Palo Verde Nuclear
Generating Station

Subject: Palo Verde Nuclear Generating Station (PVNGS)
Units 1, 2, and 3
Docket Nos. STN 50-528, 50-529, and 50-530
Application for Amendment to License Condition C.(1) Maximum
Power Level (Units 1 and 3 only), and Various Technical
Specifications to Implement Administrative Changes

ARIZONA PUBLIC SERVICE COMPANY'S EVALUATION OF THE PROPOSED CHANGE

Figure 3.4.1-1, (Page 1 of 2)
Reactor Coolant Cold Leg Temperature vs. Core Power Level

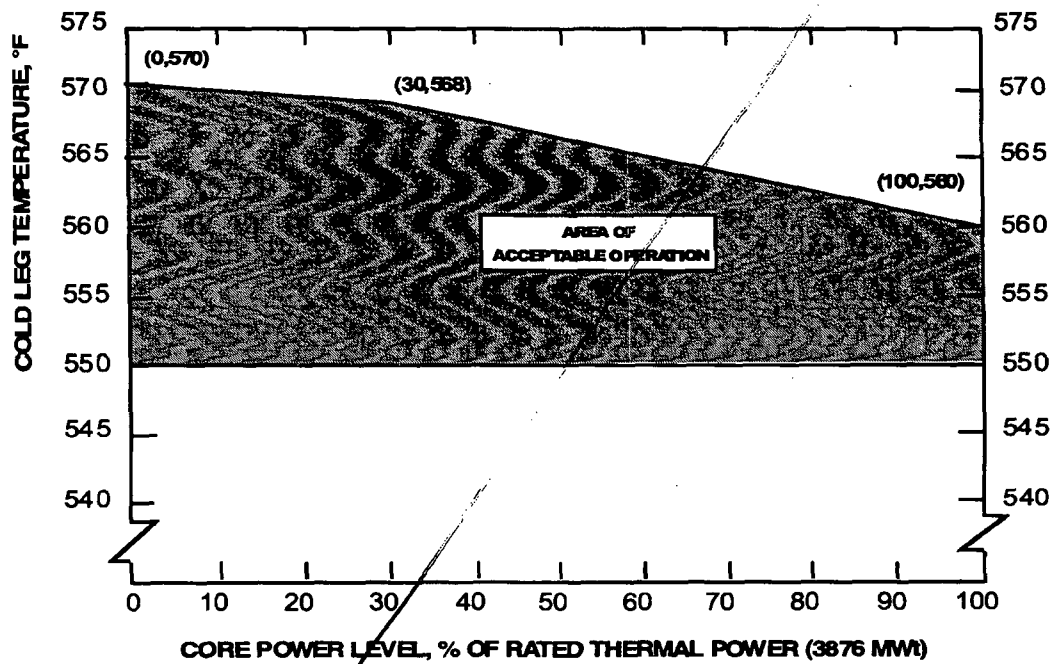
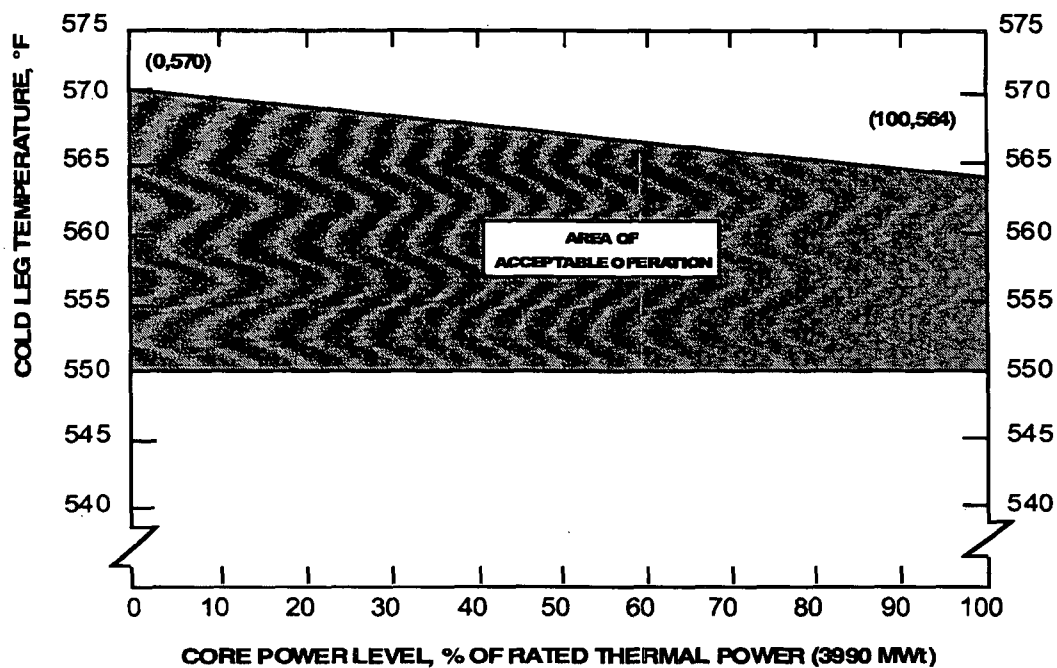
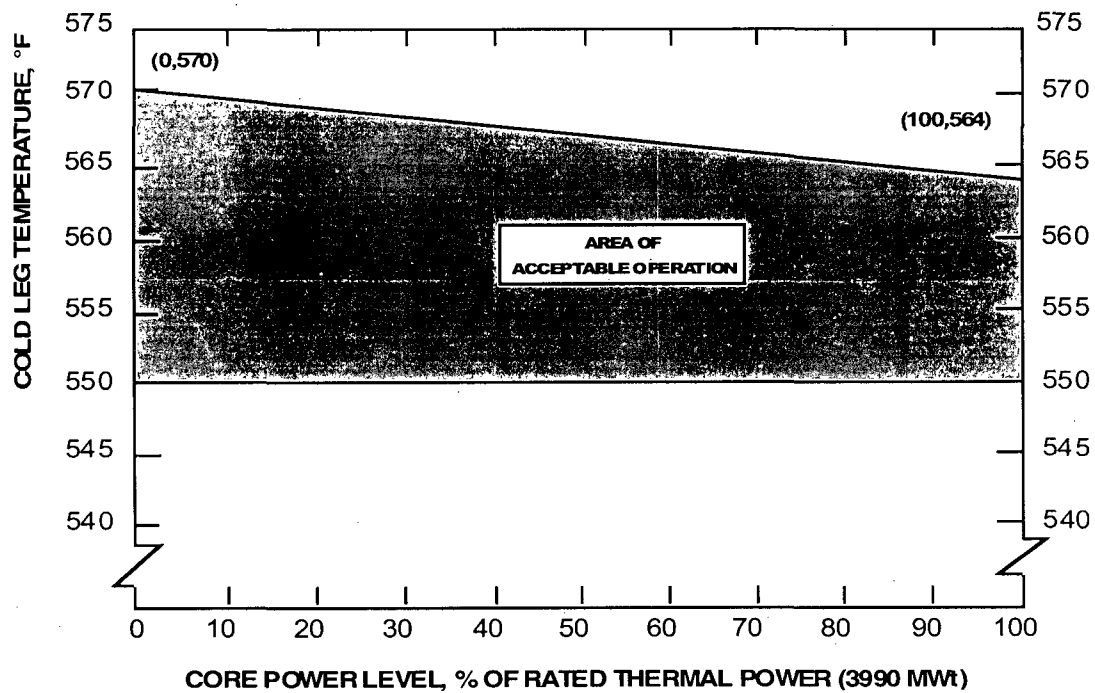
- A. Units 1 and 3 Operating Licenses, License Condition C. (1) "Maximum Power Level," and Units 1, 2, and 3, Technical Specifications 1.1 "Definitions," 3.3.1 "Reactor Protective System (RPS) Instrumentation - Operating," 3.3.2 "Reactor Protective System (RPS) Instrumentation - Shutdown," 3.3.5 "Engineered Safety Features Actuation System (ESFAS) Instrumentation," 3.4.1 "RCS Pressure, Temperature, and Flow Departure from Nucleate Boiling (DNB) Limits," and 3.7.1 "Main Steam

Safety Valves (MSSVs).” Remove superseded references to 3876 megawatts thermal (MWt) and information related to this value.

This change is administrative and is necessary to complete the Power Uprate and Steam Generator Replacement Projects. Removal of the references to 3876 MWt and information related to this value corrects the Operating License and the affected TS sections.

3876 MWt RTP

~~3990 MWt RTP~~

~~PALO VERDE UNITS 1 AND 3~~

Figure 3.4.1-1
